SUBJECT: RELOAD AMENDMENT (TAC NO. 71952)

RE: LIMERICK GENERATING STATION, UNIT 1

AMENDMENT TO FACILITY OPERATING LICENSE

Amendment No. 19
License No. NPF-39

FIGURE 3.2.1-7

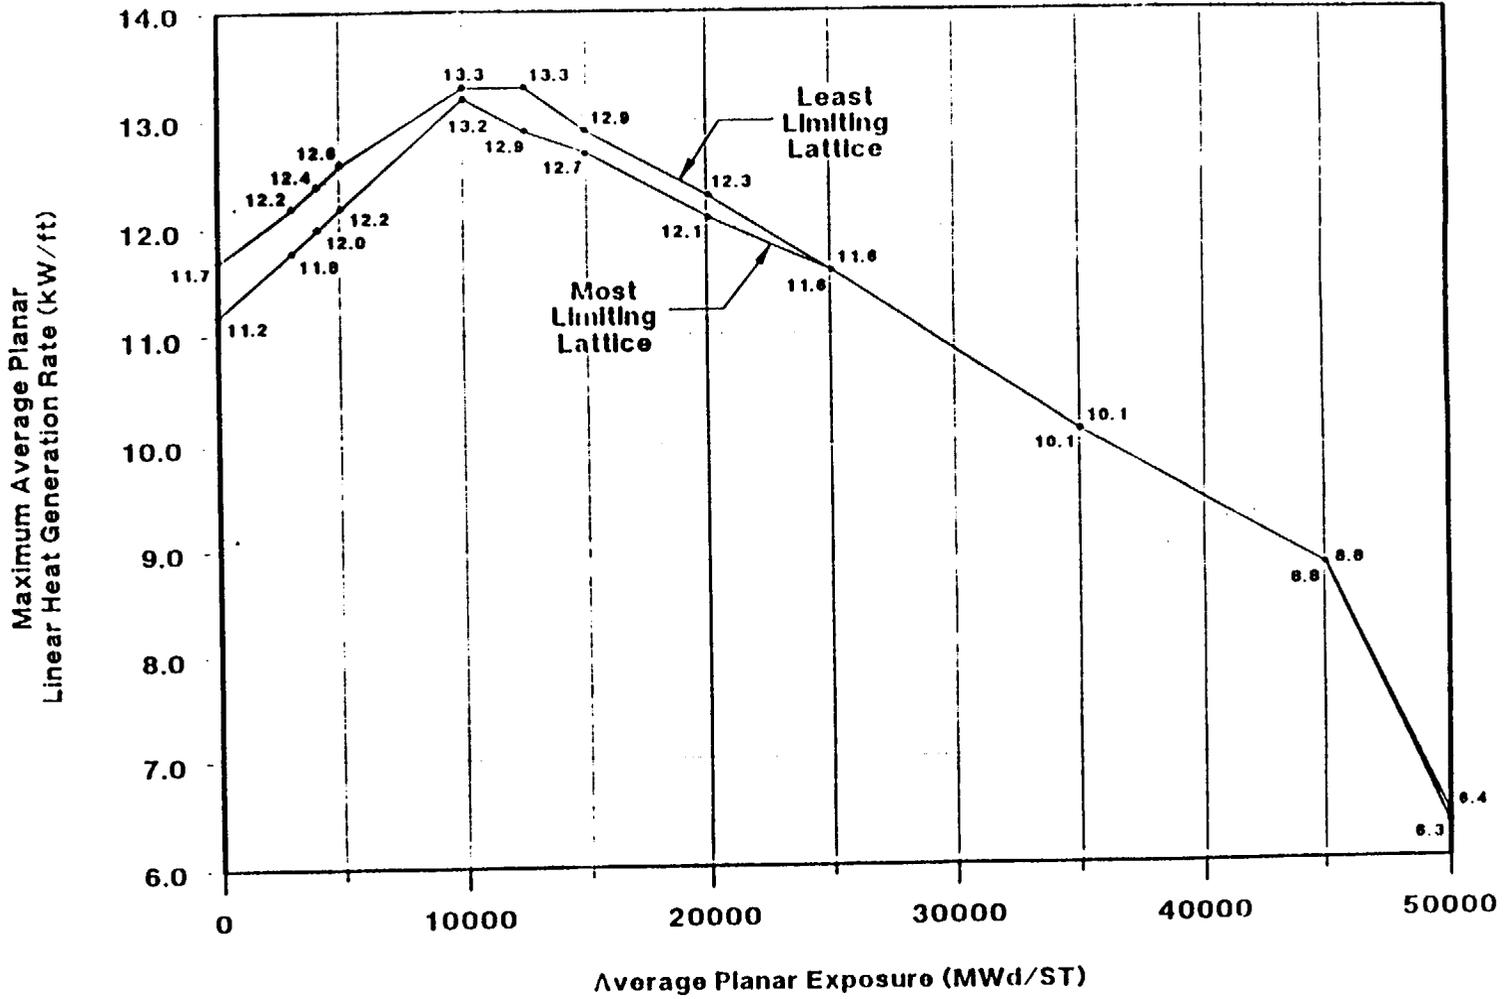
- (a) MAPLHGR limits for the new fuel were determined by approved methods. The additions are Figure 3.2.1-7 and 3.2.1-8 and are acceptable.
- (b) Revised MCPR limits for Cycle 3, for extended operation and for the new (GE8x8EB) fuel. The changes are to TS 3.2.3 and Figures 3.2.3-1a, 1b, 1c, and 1d and are acceptable.

FIGURE 3.2.3-1a

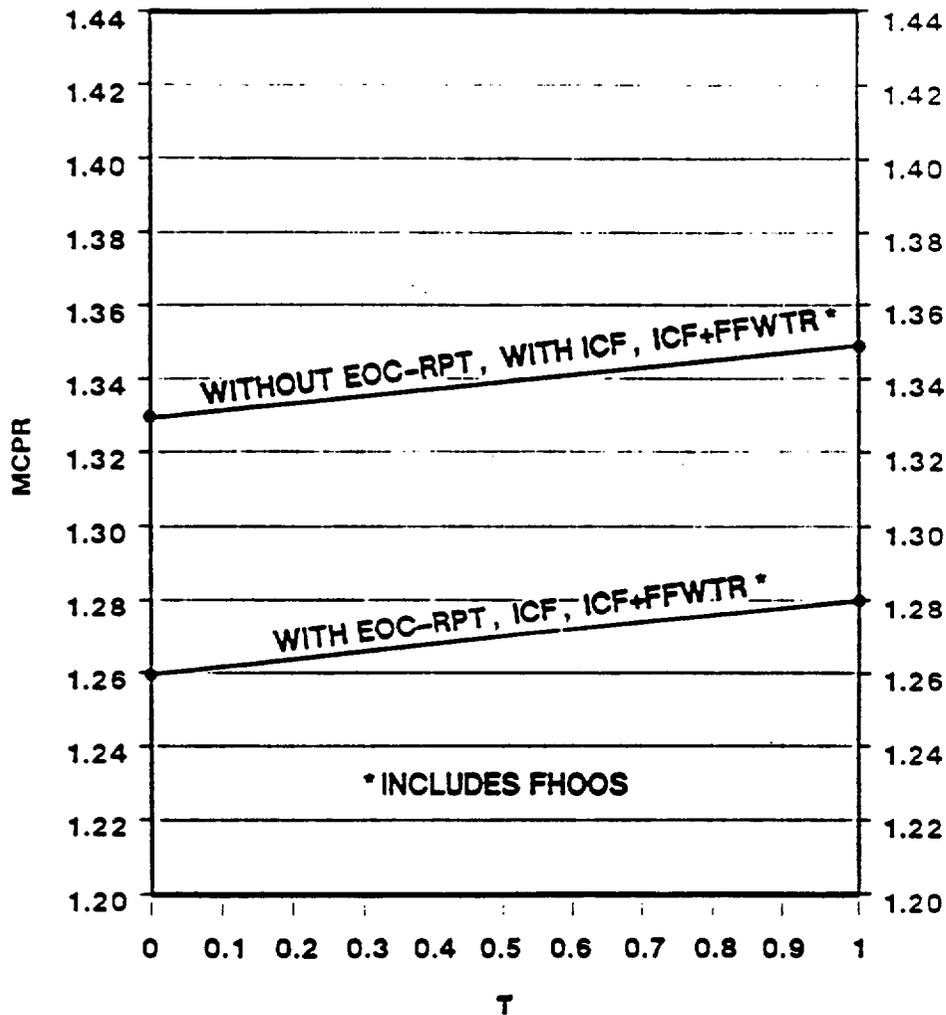
3.2.3 The MINIMUM CRITICAL POWER RATIO (MCPR) shall be equal to or greater than the MCPR limit shown in Figure 3.2.3-1a (BP/P8X8R fuel), Figure 3.2.3-1b (BP/P8X8R fuel), Figure 3.2.3-1c (GE 8X8EB fuel) and Figure 3.2.3-1d (GE 8X8EB fuel) times the K_f shown in Figure 3.2.3-2, provided that the end-of-cycle recirculation pump trip (EOC-RPT) system is OPERABLE per Specification 3.3.4.2, with:
